AGENDA

Planning Committee Meeting to be held at
Darebin Civic Centre,
350 High Street Preston
on Monday 14 November 2022 at 6.30pm.

**5.1 APPLICATION FOR PLANNING PERMIT D/745/2021
700 HIGH STREET THORNBURY**

1 A01 SHADOWS - 21 SEPTEMBER - 9AM
1 : 200

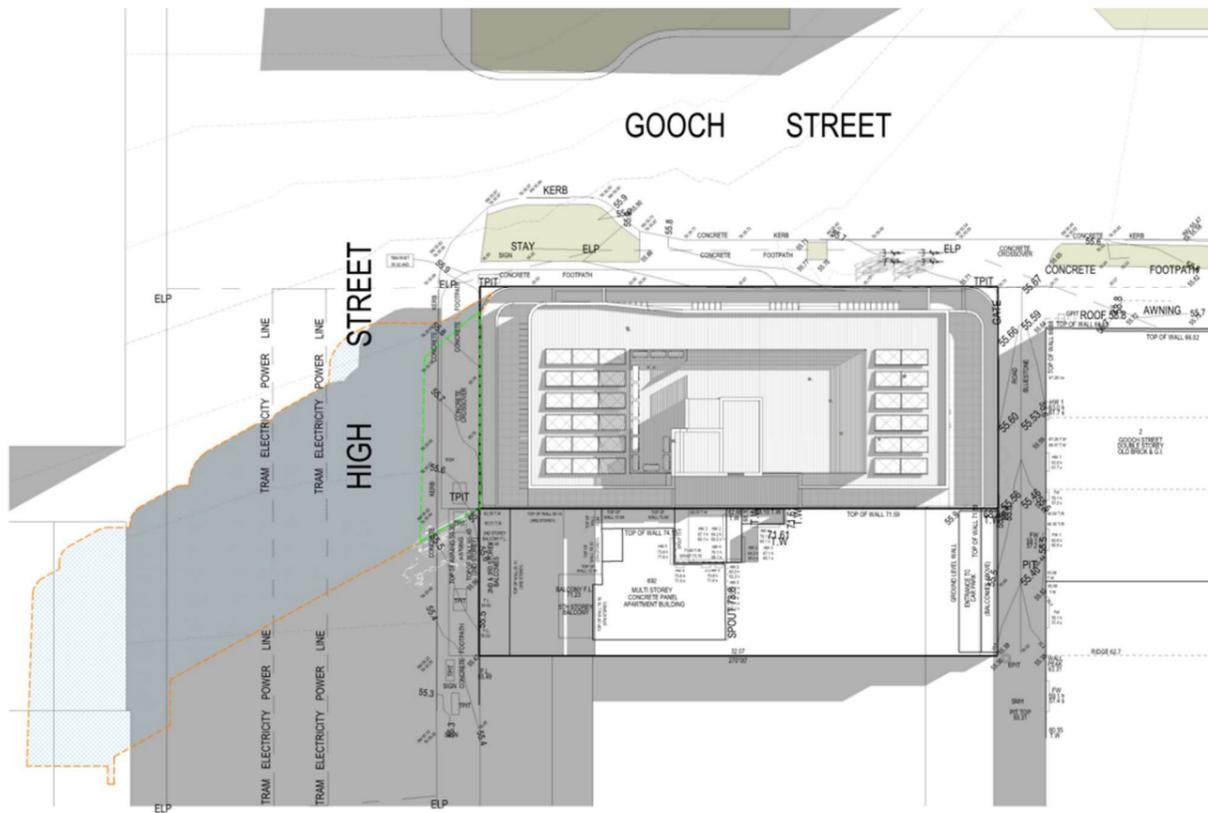
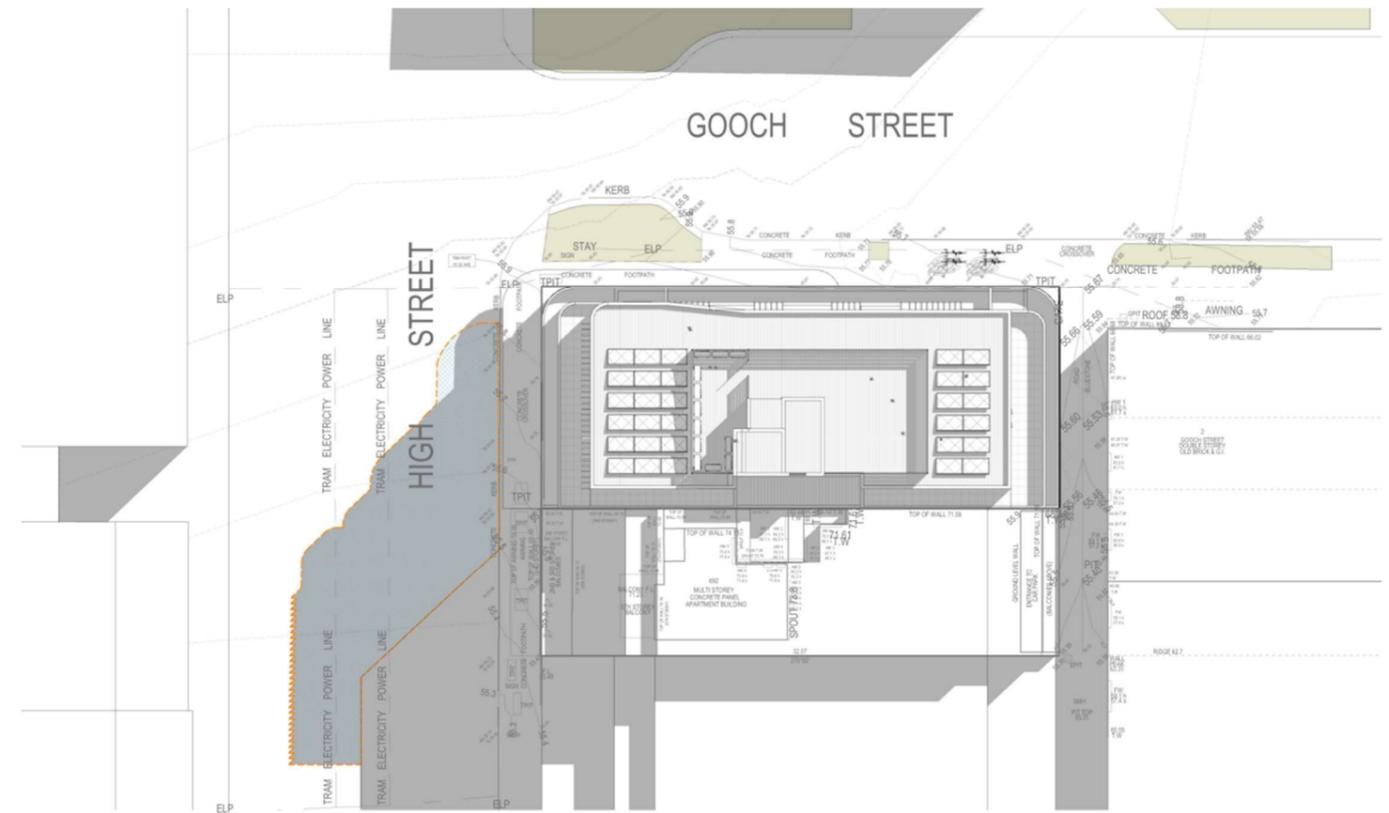
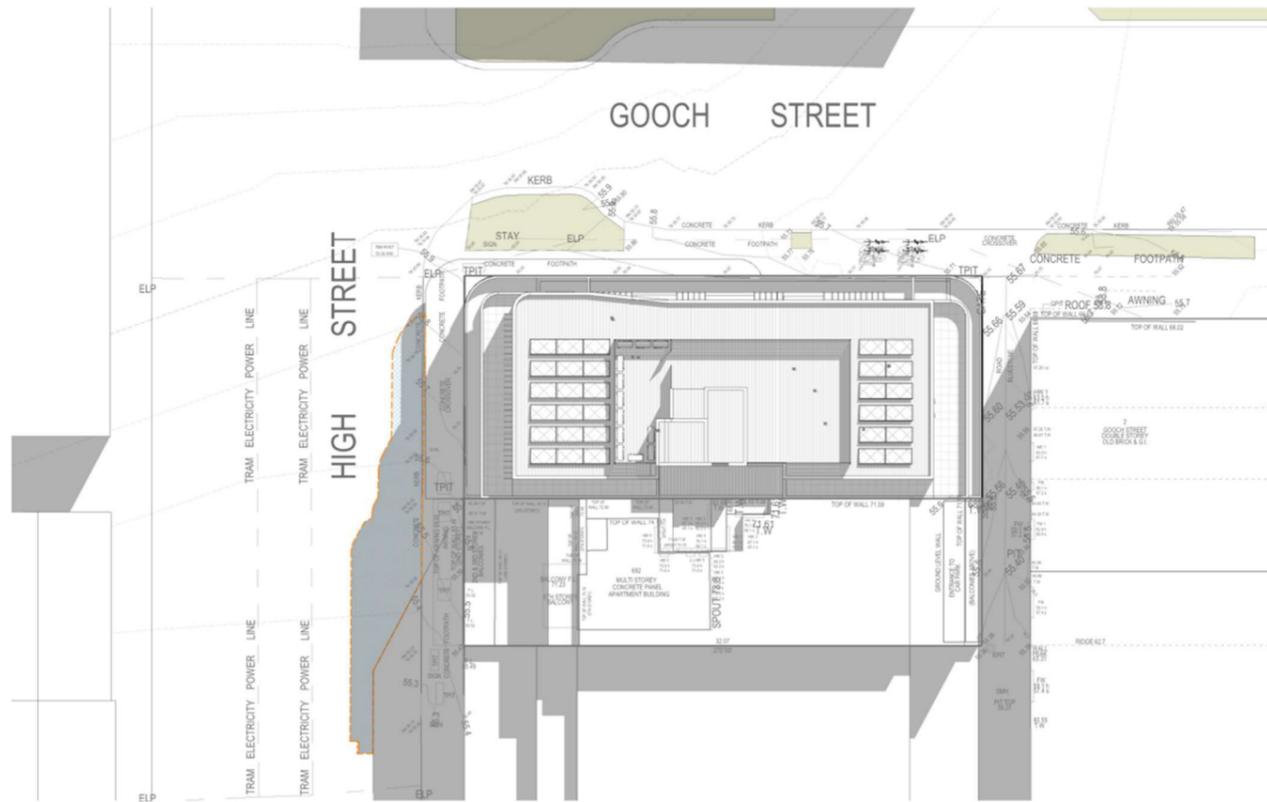
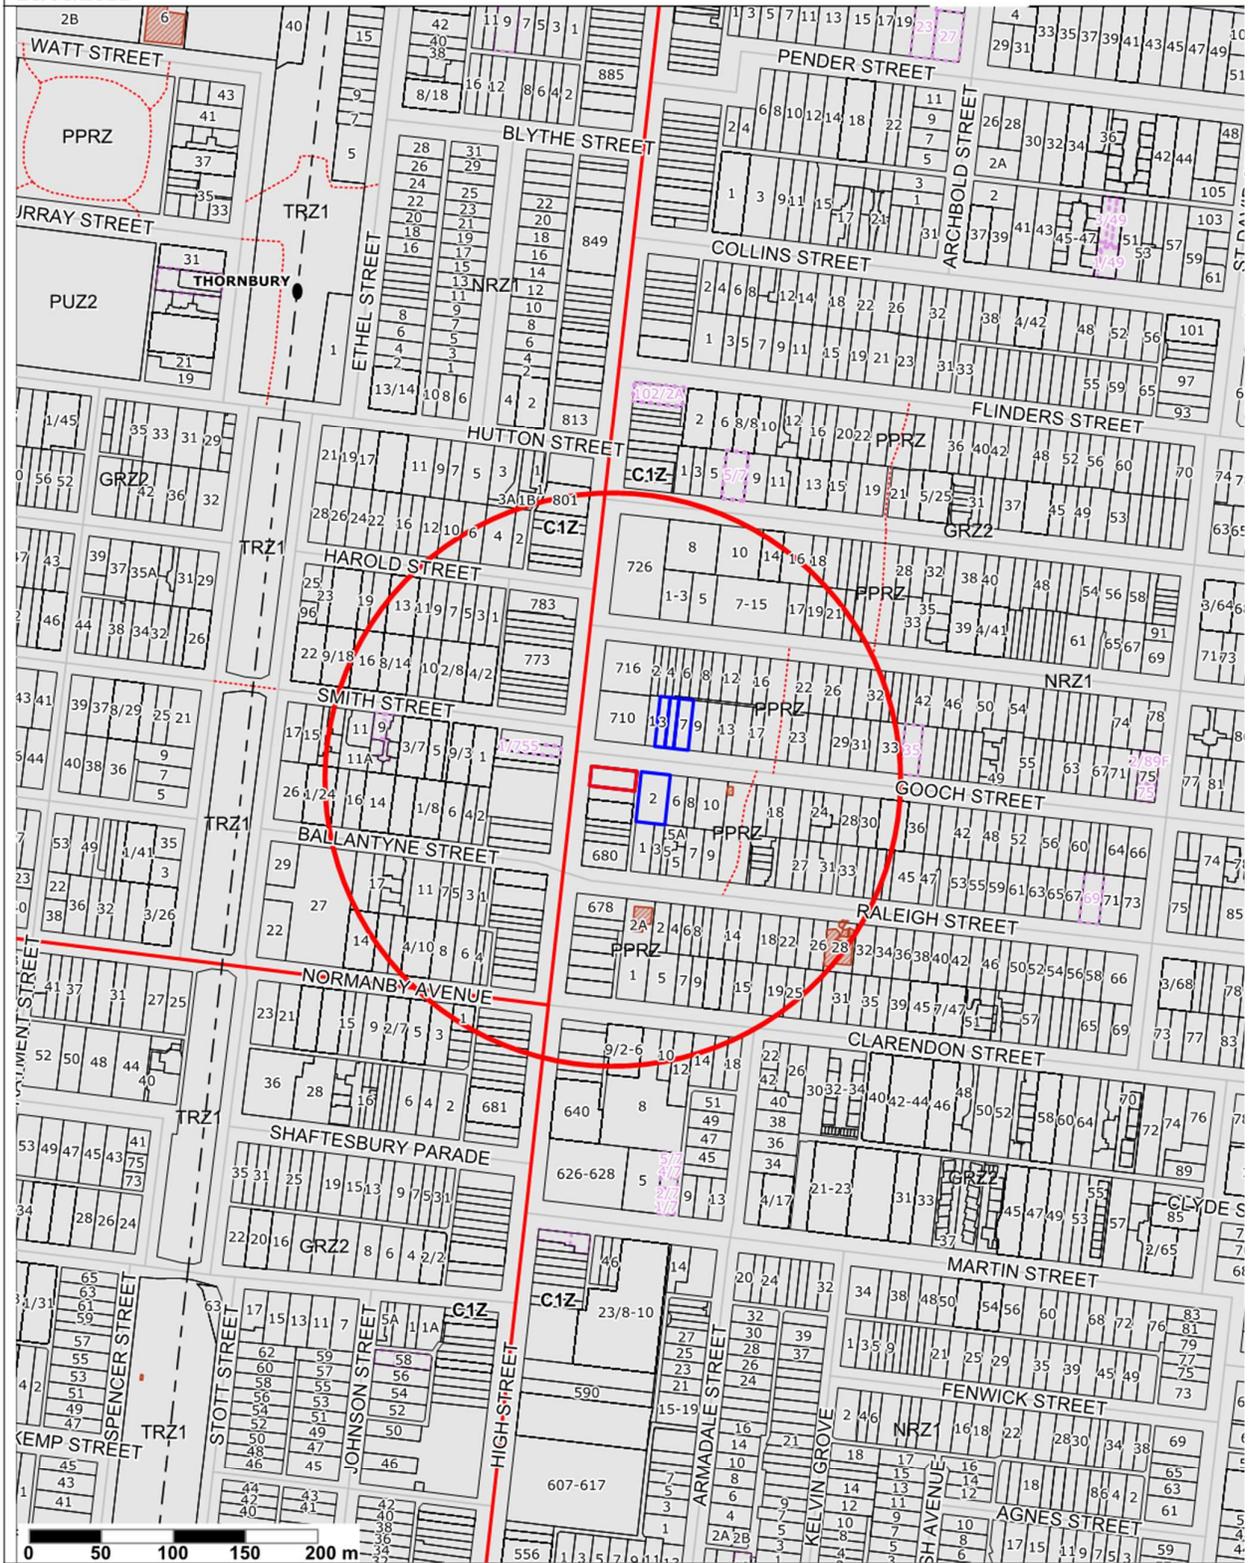
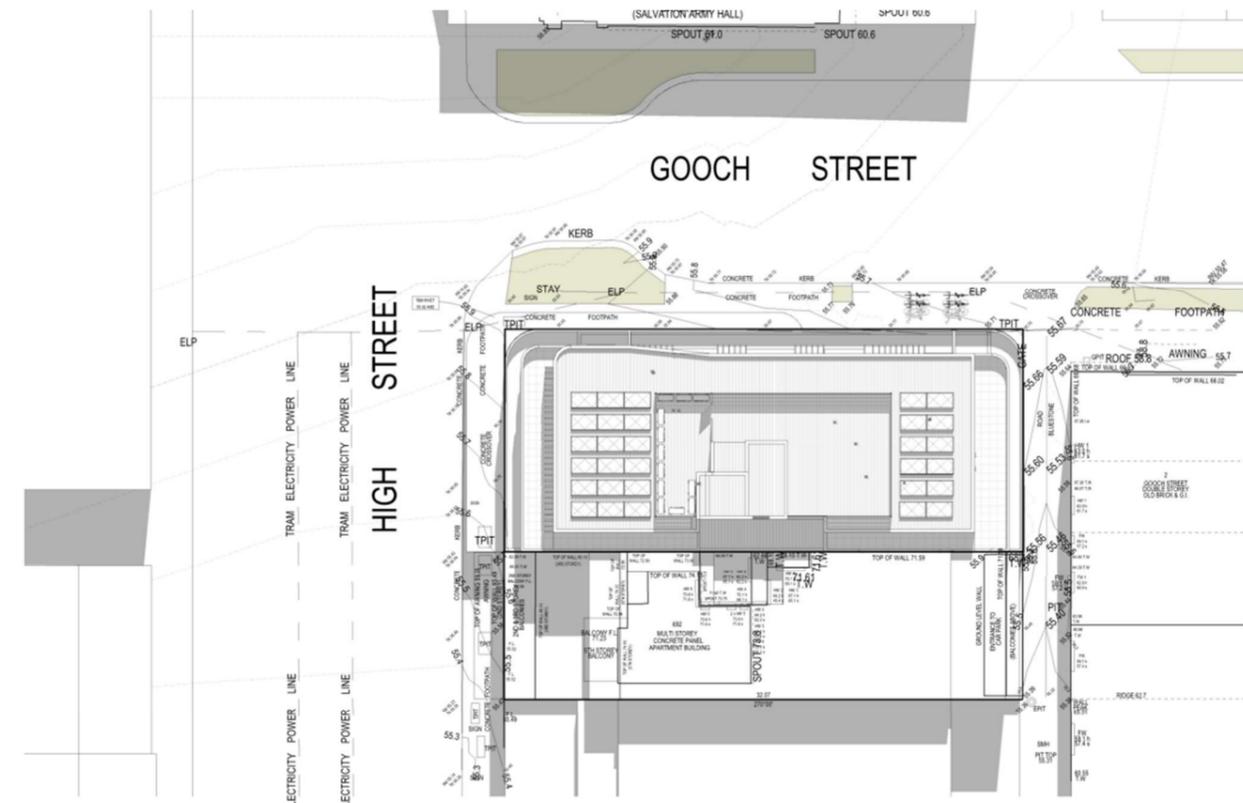
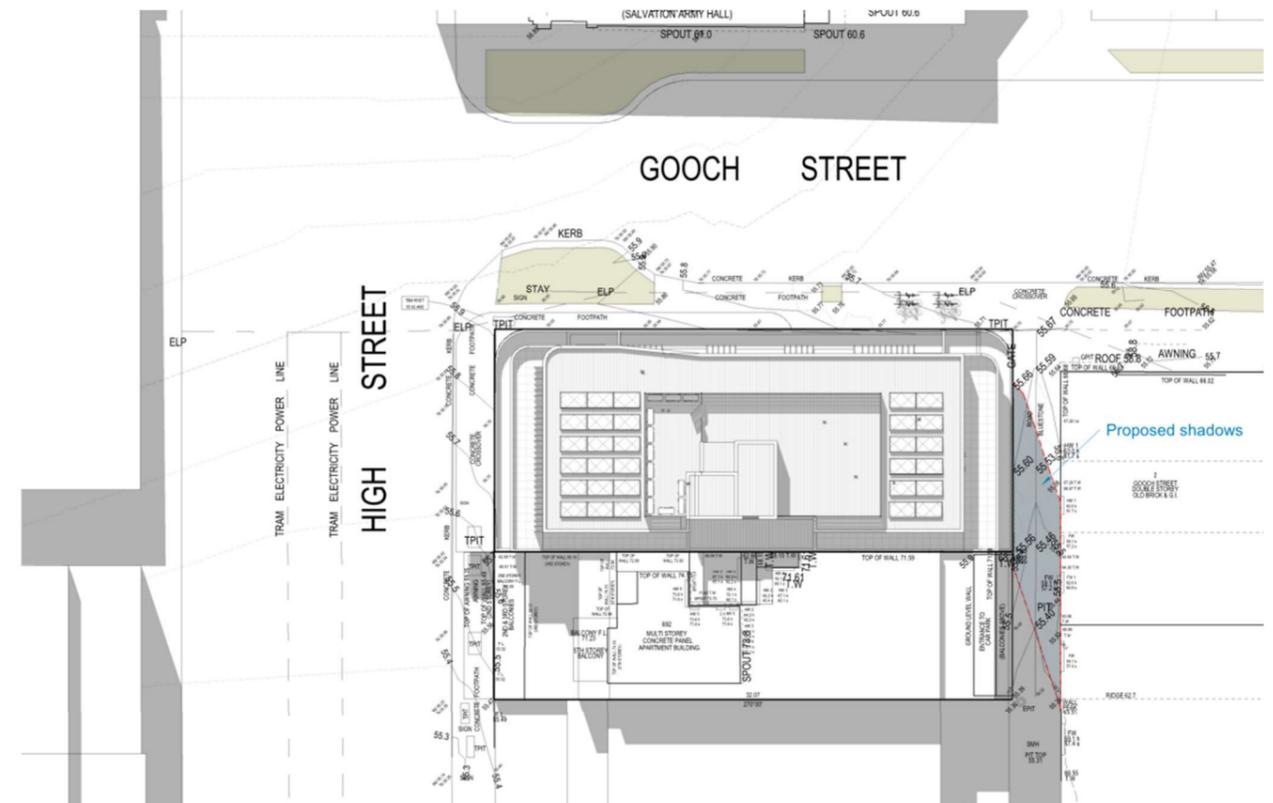
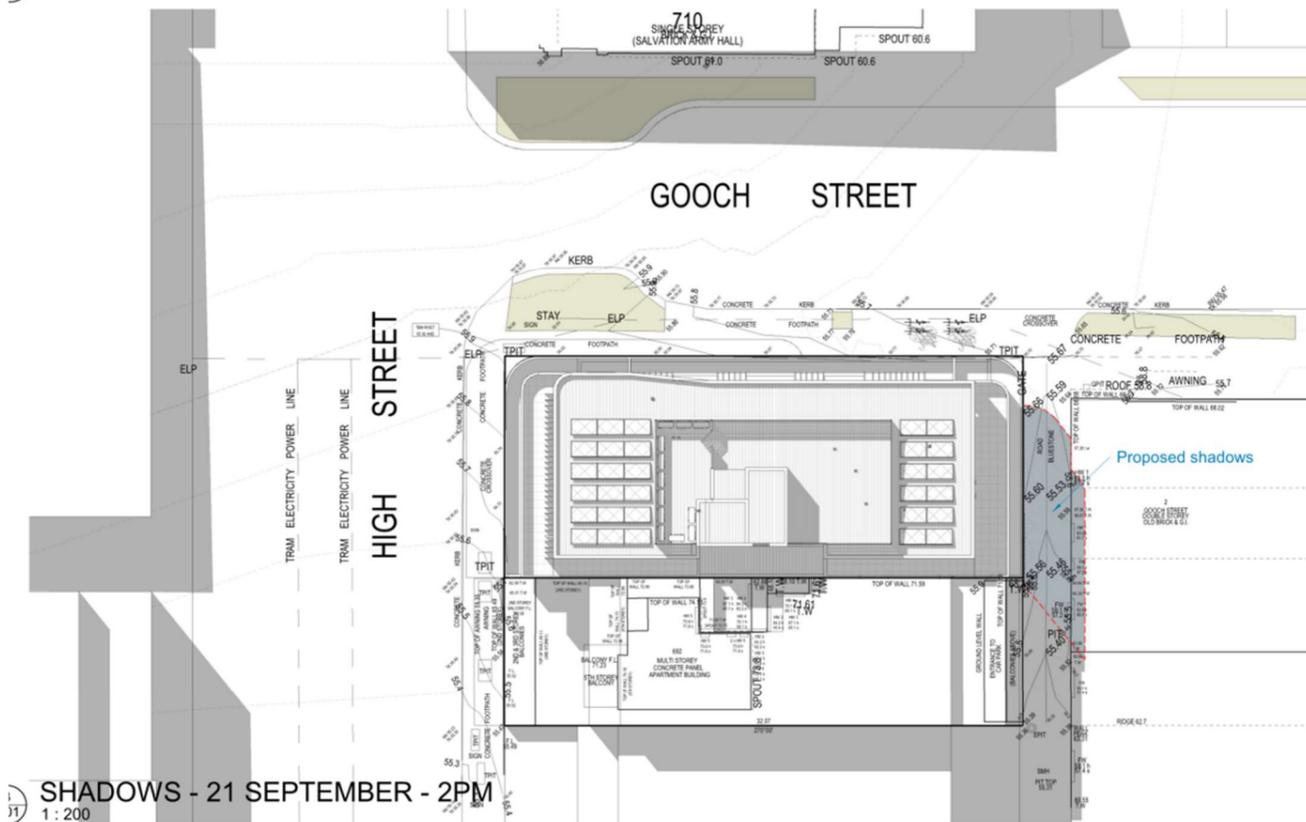
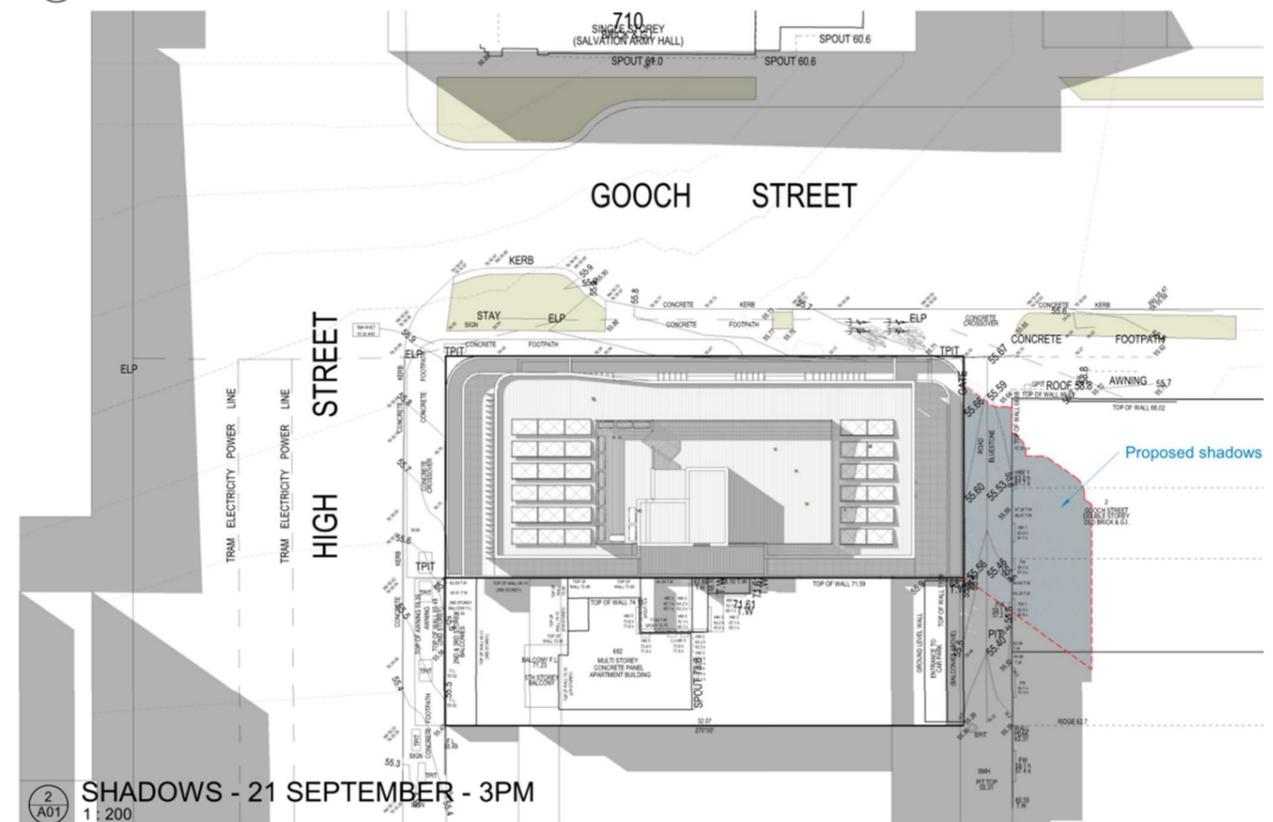
The full suite of shadow diagrams were not included with the originally advertised plans and associated documentation. The shadow diagrams provided were in relation to 9am, 10am and 11am. Consequently, objectors were provided with a full set of shadow diagrams at hourly intervals from 9am through to 3pm. This did not result in the withdrawal of any received objections.
